CHANGE NOTIFICATION

PCN# 081815

Subject: Notification of Lead Frame Change to S8E Package

Lower Standoff SOIC 8L Exposed Pad

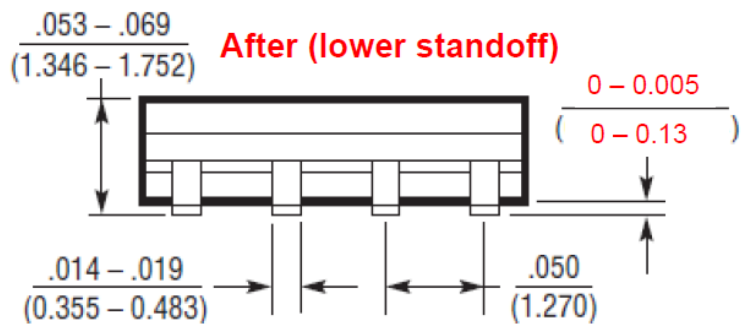
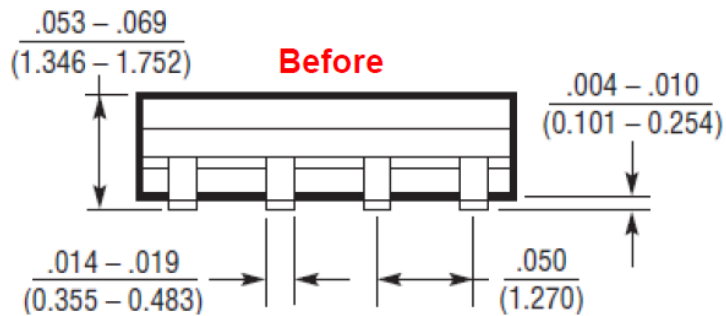
Product performance and specifications are not affected by this change in material, however the package standoff of the S8E package is being reduced to better match the standoff of the MSOP and TSSOP exposed-pad packages as shown in attached figure.

The devices built using this new lead frame material were qualified by performing full characterization over the operating temperature range. These devices were further subjected to reliability tests outlined in attached reliability data report. Products built using improved design can be identified by "e3" on the top mark as shown in attached figures. All affected part numbers are listed as follows:
